BRUNSWICK STEAM ELECTRIC PLANT  
TECHNICAL SUPPORT MEMORANDUM

TSM 91-0856

PROGRAM or  
COMPONENT ID: Diesel Generator #3

SUBJECT: Long Term Operability of EDG #3

Attachment 1

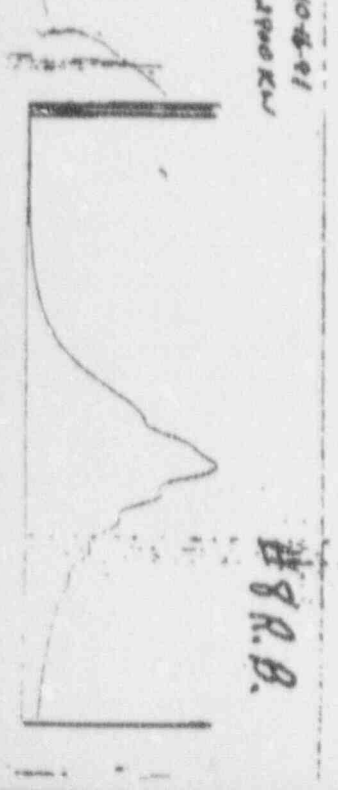
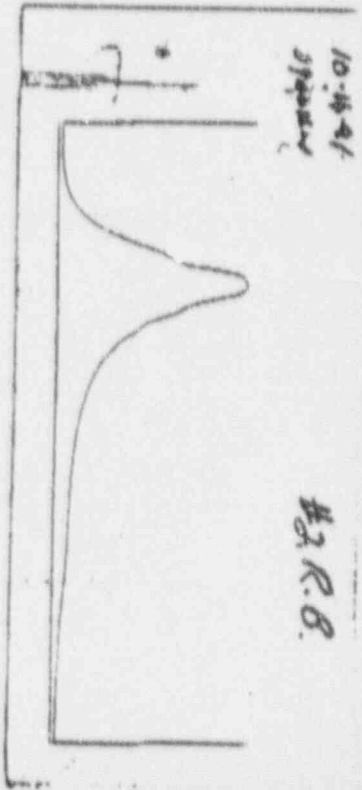
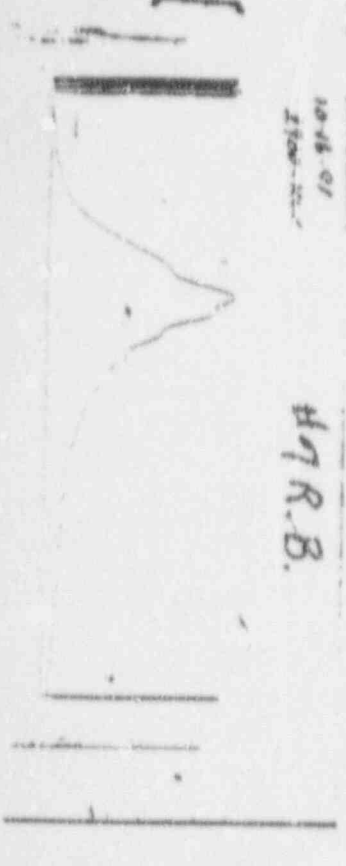
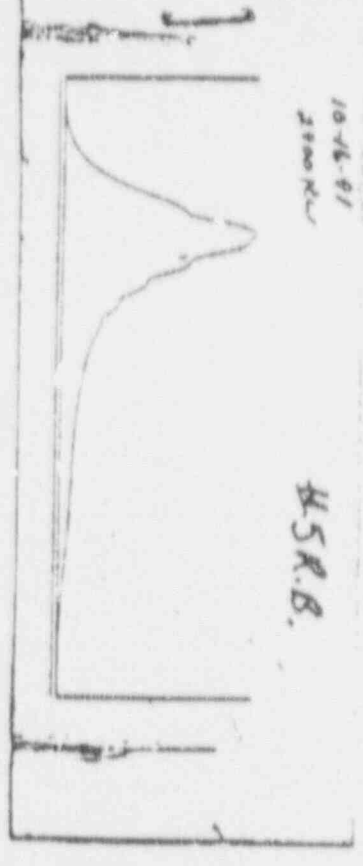
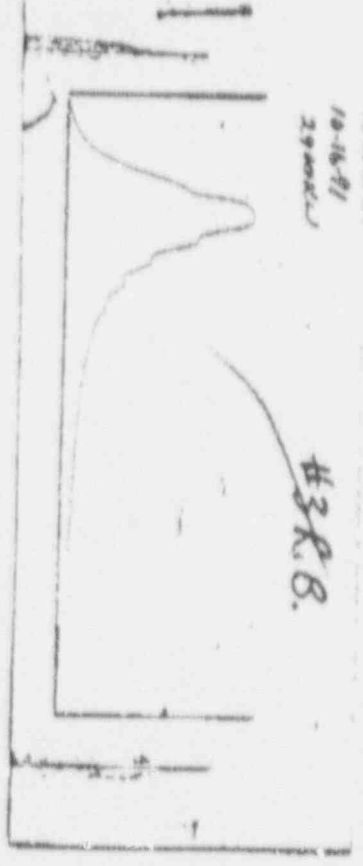
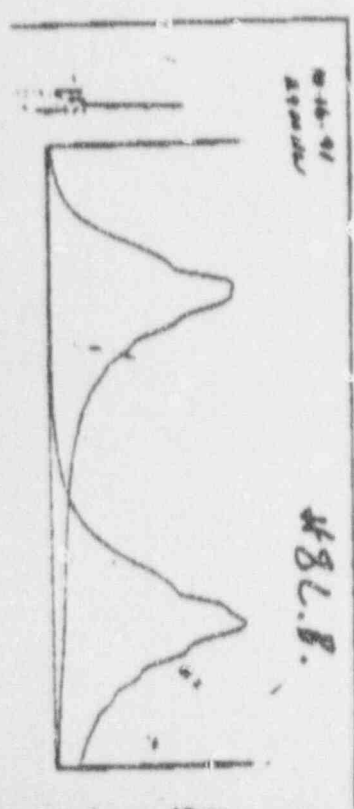
- 1) Did the high temperature damage the intake valves?
- 2) Was any of the EDG equipment damaged by the high temperature?
- 3) What parameters did the vender inspect during the run?
- 4) Is Tech Support satisfied with the current engine data?

1) No. The material of construction of intake and exhaust valves are identical except that the exhaust valves are stellite faced. Pull cards were taken on the PMTR run on 10/16/91. The pull cards measure both the compression and ignition pressures of the cylinders during actual running conditions. The compression pressures were approximately 775 psi and were within 40 psi of each other. These values were within the normal range and in close agreement with the last set of pull card readings. This indicates good cylinder compression, and therefore, no valve or valve seat damage. Additionally, besides no degradation of the valves, this analysis shows that the engine is performing well. (Reference Attachment 1)
